SPB Number: 2022.0304

EXTERIOR UPDATE

THE CLIPS BELOW ARE TAKEN FROM THE LH PROTOTYPE

STANDARD PLAN BULLETIN NOTICE
RaceTrac Engineering and Construction Division

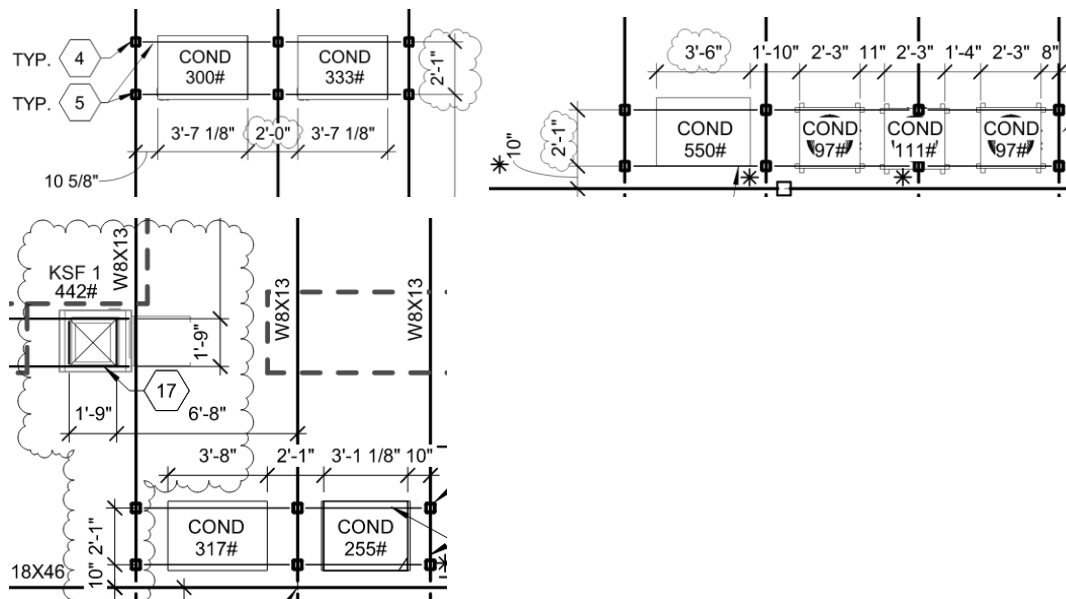
1. **PARAPET UPDATE:** Raised all the parapet heights to conceal the RTUs.

- Sheets: A126, A300, A410, A411, A420, A421, A422, A423, A430 & S201
- Attachments: A300

T.O. TOWER	24' - 5 1/4"	
T.O. CORNER TOWER	23' - 2 1/8"	
T.O. PARAPET (MED)	21' - 6 3/8"	
T.O. PARAPET (LOW)	20' - 3 3/4"

2. **BRICK UPDATE:** Updated brick to be queen brick with 1/3 running bond pattern. Updated soldier course design to align with queen brick coursing.

- Sheets: A010-1, A010-2, A010-3, A010-4, A010-5, A011-3, A011-4, A012, A013-2, A126, A201, A300, A410, A411, A420, A421, A422, A423, A430, A431, A601, A701, C101, S200 & S433
- Attachments: A300

BRICK		
BR-1	US BRICK	LAREDO (QUEEN 1/3 BOND)
BR-2	US BRICK	MOUNT RUSHMORE (QUEEN 1/3 BOND)
